LETTER OF INTENT

- **SUBDIVISION NAME:** Lorson Ranch East Filing No. 3 Final Plat is situated to the east of Marksheffel Road, north of Fontaine Boulevard, and east of the East Tributary of Jimmy Camp Creek, located generally east of Fountain, Colorado and south of the Colorado Springs Airport and is approximately 19.497 acres. This final plat incorporates a portion of the Lorson Ranch East Preliminary Plan area and will include 81 lots and one tracts for landscape/utility/buffer/open space purposes. The landscape/utility/buffer/open space tract will be owned/maintained by the Lorson Ranch Metro District. El Paso County Project Number SF 19-0xx has been assigned to this project.

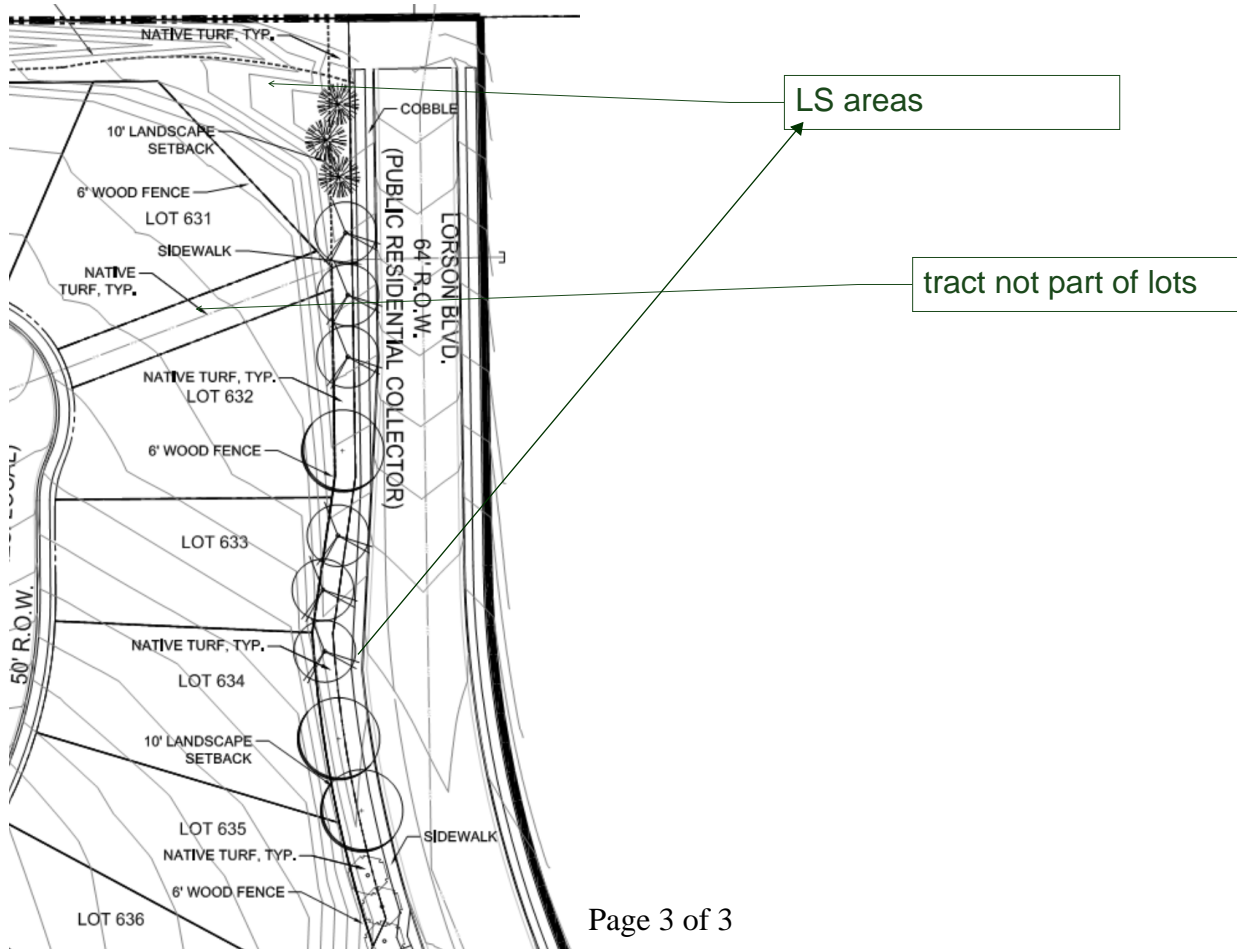
Add tract between lots as shown on PUD

Add tract between lots s shown on PUD

tract not part of lots

LS areas
